**Takes of Marine Mammals Incidental to Specified Activities; Taking Marine Mammals Incidental to Tugs Towing Drill Rig in Cook Inlet, Alaska**

**ACTION:** Notice; issuance of incidental harassment authorizations.

**SUMMARY:** In accordance with the regulations implementing the Marine Mammal Protection Act (MMPA) as amended, notification is hereby given that NMFS has issued two incidental harassment authorizations (IHAs) to Hilcorp Alaska LLC to incidentally harass, by Level B harassment only, marine mammals during tugs towing jack-up rig activity in Cook Inlet, Alaska.

**Figure 3 -- A map of the Susitna Delta exclusion zone and aerial survey area**

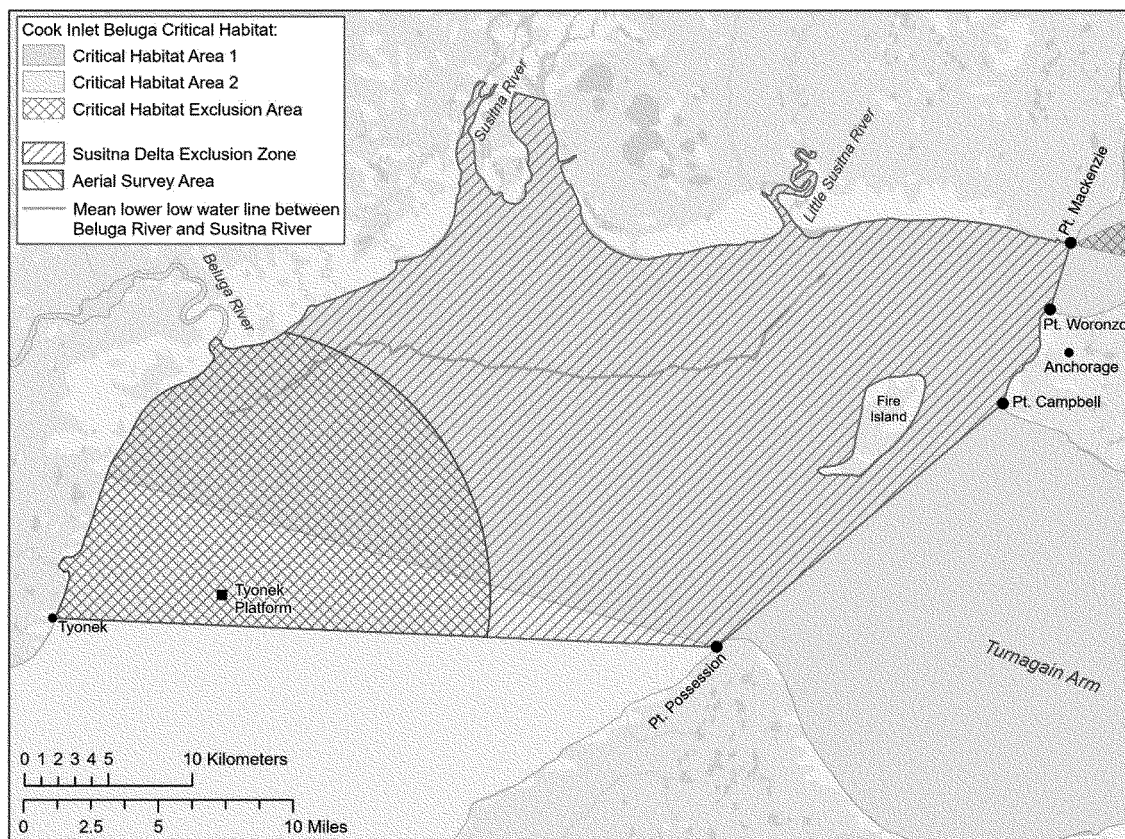
During the process of section 7 consultation under the ESA, Hilcorp notified NMFS that complying with the Susitna Delta mitigation zone as proposed would not be practicable for operations at their Tyonek platform because the location of the platform is within the Susitna Delta exclusion zone. The dates and applicability of the Susitna Delta exclusion zone have been changed from the proposed to final IHAs. The changes, as well as additional protective measures associated with the change, are described in more detail in the Mitigation section below.

During the course of consultation under section 7 of the ESA, Hilcorp notified NMFS that adhering to the exclusion zone for the Tyonek platform would not be practicable given the operational and human safety concerns of accessing the platform outside of the open water season. Prior to tugging the jack-up rig to and from the Tyonek platform, Hilcorp will conduct a systematic aerial survey of all marine waters within a 10 mile radius of the Tyonek platform that intersects with the Susitna Delta exclusion zone, termed the aerial survey area (see Figure 3) to ensure the area is clear of beluga whales. Aerial surveys will be flown with a PSO observing for beluga whales at an altitude of approximately 1,000 ft (305 m). This survey will be conducted no more than 12 hours (one half of one tide cycle) prior to the proposed departure of the rig from its moored or anchored location. If beluga whales are observed during the aerial survey prior to mobilizing the jack-up rig to or from the Tyonek platform, Hilcorp will not begin mobilization of the rig until a subsequent aerial survey indicates the aerial survey area contains no beluga whales. Starting from the proposed
